REQUEST

Current Zoning: O-2 PED (office, pedestrian overlay)
Proposed Zoning: MUDD-O PED (mixed use development, optional, Pedestrian Overlay)

Approximately 0.94 acres located at the southeast intersection of Commonwealth Avenue and The Plaza, north of East Independence Boulevard.

SUMMARY OF PETITION

• Proposed Request Details

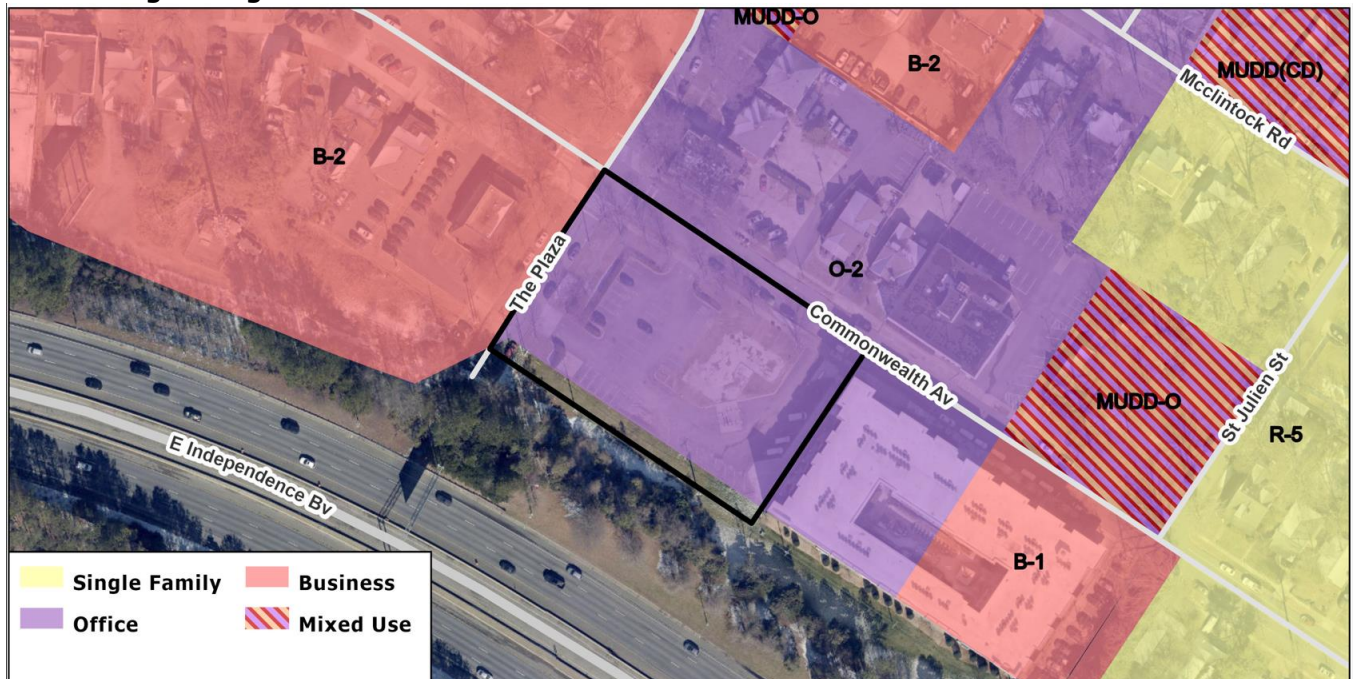
1. Show required right-of-way trees.

2. Comprehensive Transportation Review (CTR): The Comprehensive Transportation Review was recently approved by City Council under the new UDO. In lieu of a TTM for the proposed site CDOT has requested the petitioner complete a CTR for the site. The petition's zoning falls within the medium to high intensity development which based on the 1,775 daily trips will trigger Tier 3 (14 mitigation points) for multimodal assessment and Tier 3 (6 mitigation points) for transportation demand management assessment. The petitioner shall review and assess the publicly accessible pedestrian network within ¼ mile walking distance of the site to identify multimodal infrastructure to meet the Tier 3 (14 mitigation points) for multimodal assessment. Petitioner shall also provide transportation demand management strategies to meet Tier 3 (6 mitigation points) to reduce vehicle trips and encourage alternative modes of transportation.

3. Reduce the maximum height to provide contextual sensitivity to the surrounding building forms.
4. Revise note 7 under the Design Guidelines to commit to community benefits to achieve building height above 80'. Commit to specific community benefits.
5. Identify building envelopes(s) rather than one development area.
6. Remove optional provision allowing for a drive-through.
